## Revolution counter for ROTAX 447 SCDI

This Service Information makes Service Information 7 UL 91-E for Type 447 UL SCDI void.

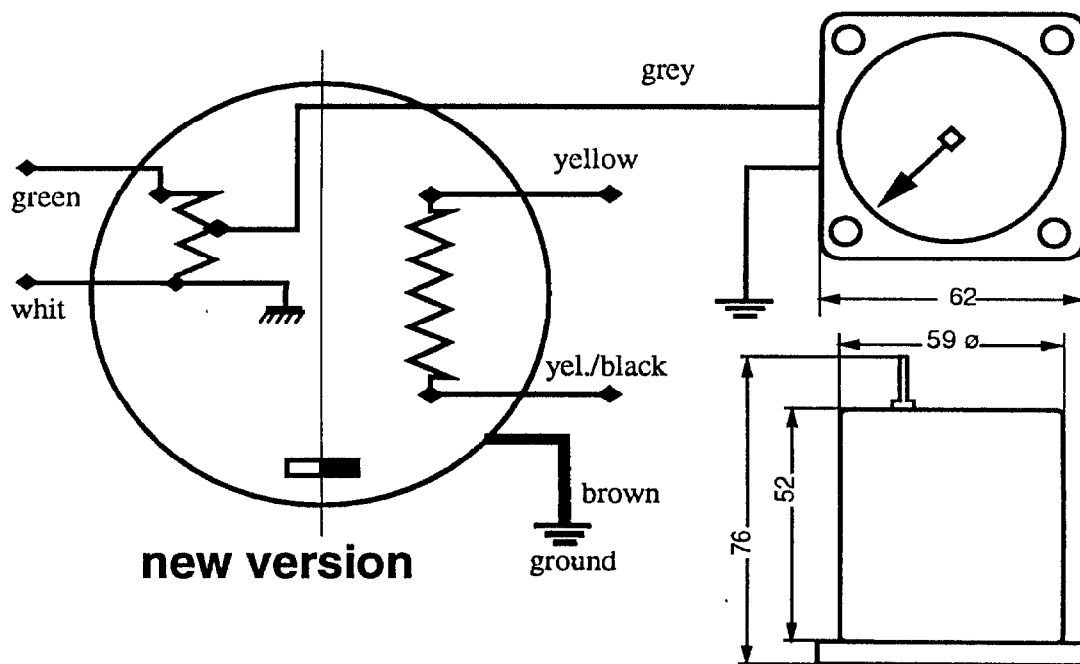
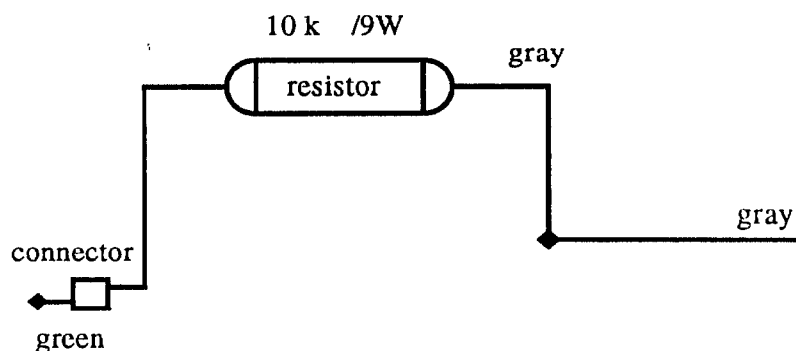
This information refers only to ROTAX 447 UL engines with electronic SCDI (single capacitor discharge) ignition. With introduction of magneto generator (ROTAX part no. 996 833) as of engine no. 3,910.411 no additional resistor is necessary for operation of the electronic tachometer (ROTAX part no. 966 074). The tachometer is connected directly to the gray cable.

◆ Note: As shown in the wiring diagram, no additional external current supply is necessary. Never connect the tachometer directly to an ignition circuit or to the lighting coil, but only to the central tapping wire (gray) of the charging coil.
